ADDENDUM NO. A

Date: January 8, 2026

Owner: Food Bank of Northern Nevada
550 Italy Drive
McCarran, Nevada 89434

Addendum 'A' consists of thirteen (13) items, thirty five (35) answered questions, and four (4) attachments

E0.02

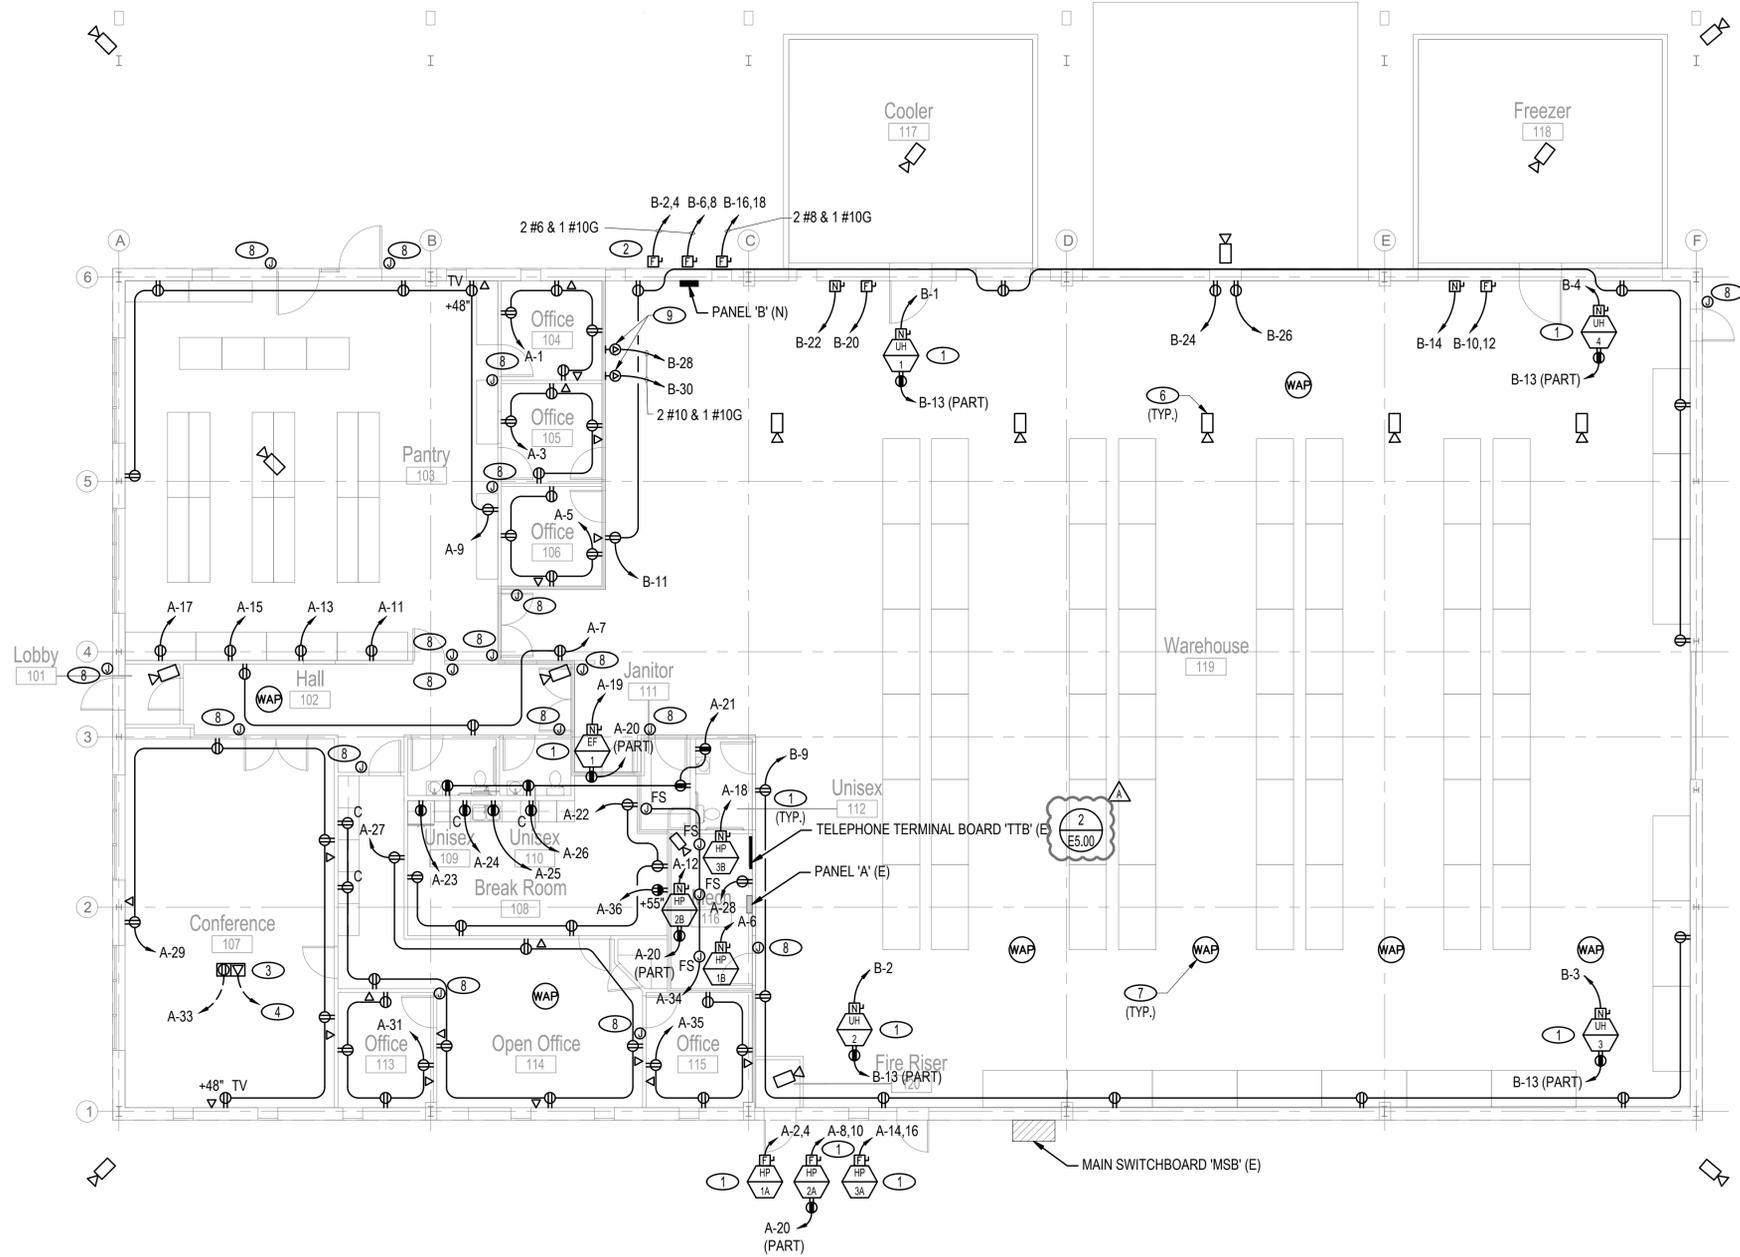
Sheets e0.02, e3.01, and e5.00 were revised to show a new light at the canopy ceiling near the pantry entrance.

E2.01

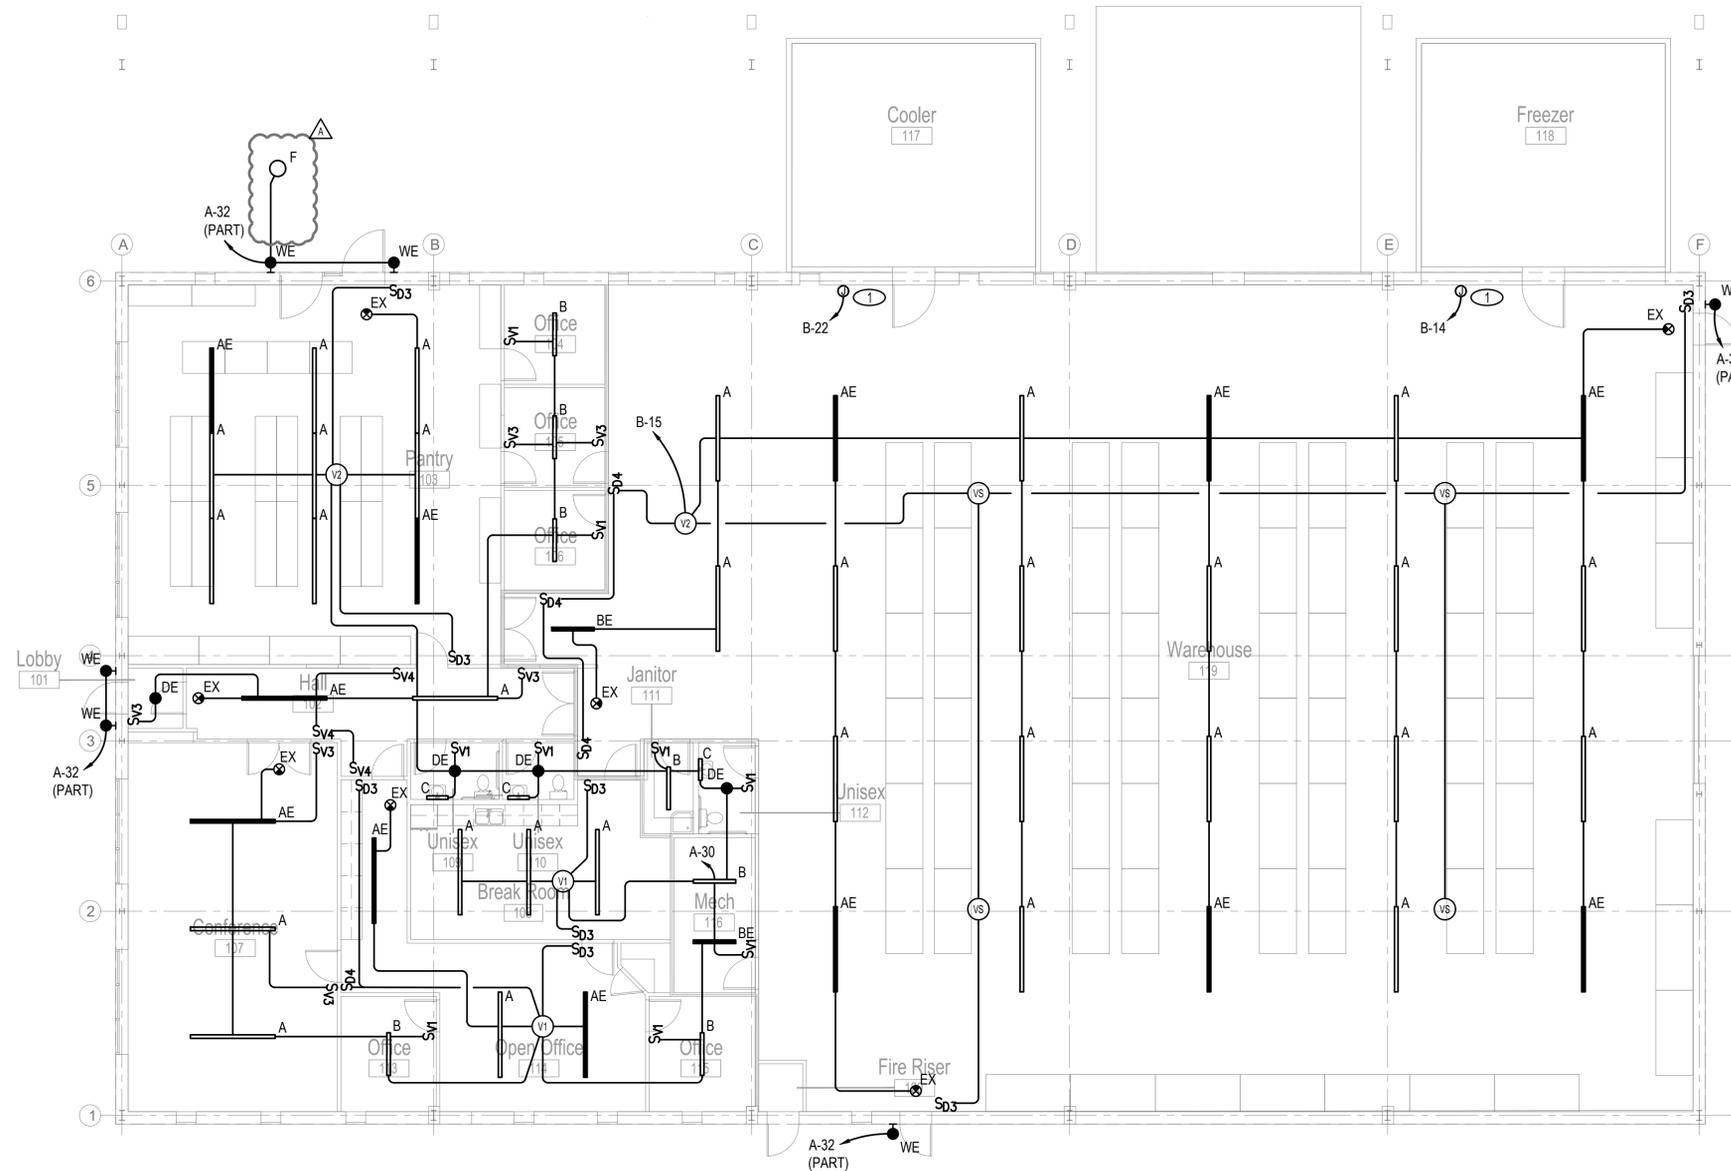
Sheets 2.01 and e5.00 have been revised to call out low voltage connection requirements and minimum AIC rating for ATS

KEY NOTES

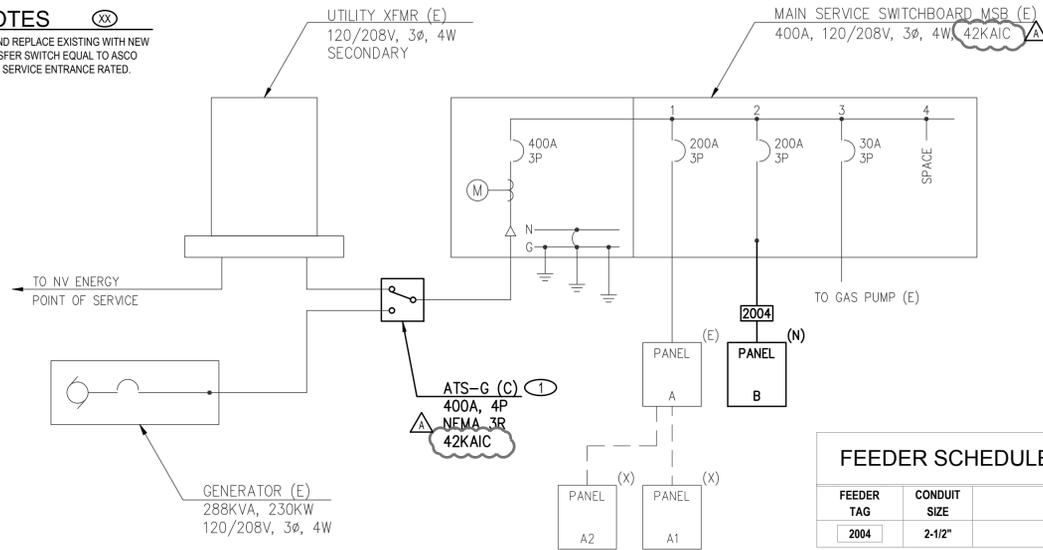
26- The one line diagram on E5.00 shows the ATS on the utility power side. Is this correct? **Record drawings do not indicate an ATS, however generator and ATS were discovered in field. Confirm exact wiring configuration in field, scope is to remove and replace existing ATS only. ATS shall be service entrance rated.**

27- Is the 100kaic rating on the main switchboard accurate? **No, the existing rating is unknown. Record drawings do not indicate AIC rating. Verify rating in field.**

- REMOVE AND REPLACE EXISTING WITH NEW 400A TRANSFER SWITCH EQUAL TO ASCO 300 SERIES SERVICE ENTRANCE RATED.
